Re: Florida Power & Light Company
Proposed Turkey Point Units 6 and 7
Docket Nos. 52-040 and 52-041
Voluntary Revised Response to NRC Request for Additional Information Letter No. 043 (eRAI 5875) SRP Section - 02.05.03 Surface Faulting

Re: Florida Power & Light Company
Proposed Turkey Point Units 6 and 7
Docket Nos. 52-040 and 52-041
Voluntary Revised Response to NRC Request for Additional Information Letter No. 043 (eRAI 5875) SRP Section - 02.05.03 Surface Faulting

NRC RAI Letter No. PTN-RAI-LTR-043

SRP Section: 02.05.03 – Surface Faulting

Figure 1 Illustration from USACE Lineament Study and Barnett (1975) Strike-slip Fault

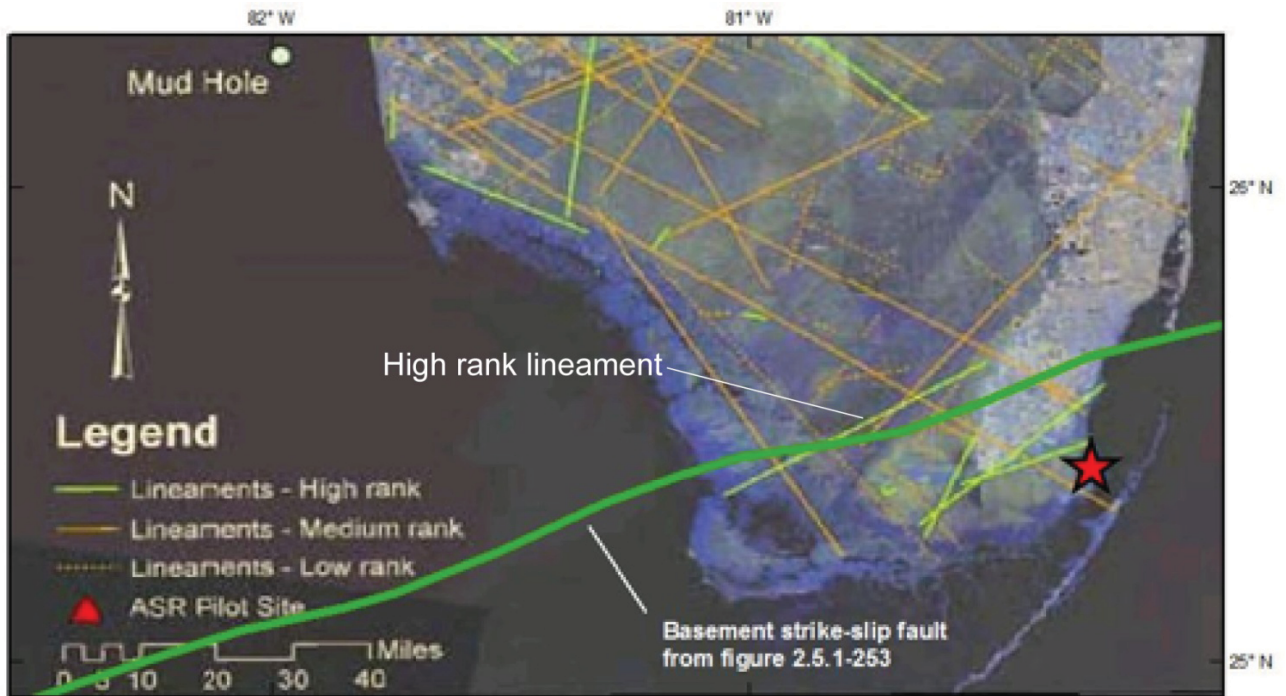
In order for the staff to completely understand the geologic setting of the site and in support of 10 CFR 100.23 please discuss the high-rank lineament shown on Figure 2.5.3-204, and clarify it's relationship with the strike-slip fault north of TPNPP shown on Figure 2.5.1-253. Include a discussion regarding how these figures are in agreement with the FSAR Section 2.5.3.2 statement that no faults have been mapped in the site vicinity. Finally, please clarify this apparent disagreement between the text and figures in the appropriate FSAR section(s).

There is no clear relationship between the postulated buried strike-slip basement fault depicted in FSAR Figure 2.5.1-253 and the high-rank lineament on FSAR Figure 2.5.3-204. As shown in Figure 1, the two features are both northeast-striking, but have different geometries, extents, and locations. The high-rank lineament is more north-striking,

completely straight and mapped onshore, terminating at the Atlantic coastal ridge, while the postulated basement fault strikes more easterly, has a variable strike, and extends tens of kilometers offshore both to the east and west. Where the high-rank lineament is most well defined (at its southwest end, near the mouth of the Shark river), the basement fault is located more than 5 km to the north (Figure 1). No geologic evidence of faulting is reported to support a tectonic origin for the lineaments identified in the USACE study, and no evidence links the postulated basement faults at depth to any lineament at the surface (FSAR 2.5.3 Reference 232). The original study by Barnett (1975) (FSAR 2.5.1 Reference 458) did not interpret geomorphic expression of any of the postulated basement faults depicted in FSAR Figure 2.5.1-253. FPL interprets the similarity in general location (southern Florida) and strike (northeast) of the high-rank lineament and postulated basement fault to be coincidental. Because the high-rank lineament in FSAR Figure 2.5.3-204 is not associated with faulting, this figure provides no conflict with FSAR statements regarding faulting within the site vicinity.

Figure 1 Map of McGregor Isles Area

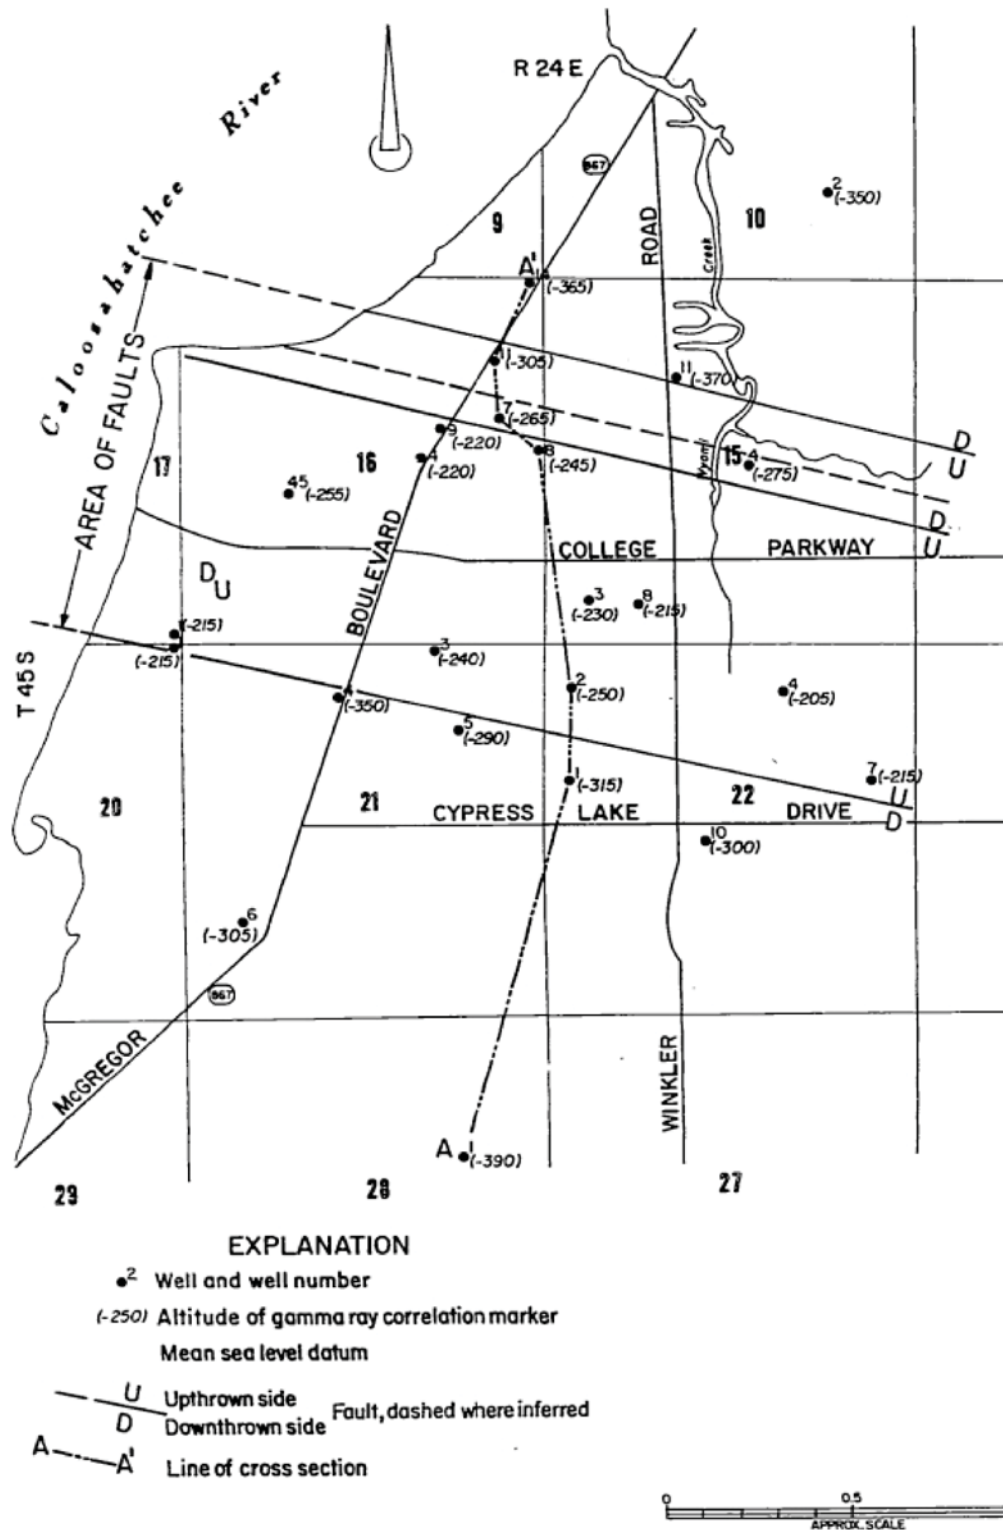
In order for the staff to understand evidence for or against tectonic deformation in Florida Platform specific geology and in support of 10 CFR 100.23, please clarify the apparent inconsistent conclusions that Sproul et al (Reference 230) drew regarding these possible faults. Describe the geomorphic features that Sproul et al referred to and provide more details of your field reconnaissance examination of this area completed for this application.

Sproul et al. (1972) (FSAR 2.5.3 Reference 230) suggest that the “configuration of the Caloosahatchee River shoreline in the vicinity of the northeast corner of section 17 (in Figure 1), and the alignment of a tributary to Whiskey Creek near the center of section 15 are suggestive of fault controlled features” (p. 12 of FSAR 2.5.3 Reference 230) (see Figure 1). The shoreline throughout the northwest corner of section 16 and the southwest corner of section 17 is not aligned with the faults, but a bend in the shoreline does occur near the northern group of 3 faults (see Figure 1). However, the fault located at the apex of the bend is dashed and listed as “inferred”. If the shoreline bend had resulted from Quaternary faulting, the geometry of the bend would indicate apparent dextral slip, not dip-slip as interpreted based on stratigraphic displacement of the marker bed. Surficial strata in this area are mapped as unfaulted Tertiary-Quaternary shell units (Reference 1).

Although the short tributary to Whiskey Creek is subparallel to the proposed faults, the orientation of the main creek drainage in section 15 is at high angles to the trace of the mapped faults, with no apparent offset or deflection along the proposed structures (See Figure 1). A comprehensive geologic mapping effort in Lee County and the Caloosahatchee Basin utilizing well cuttings, cores, quarry pits and the limited natural outcrops does not indicate any surficial faulting in the area (e.g., Reference 1).
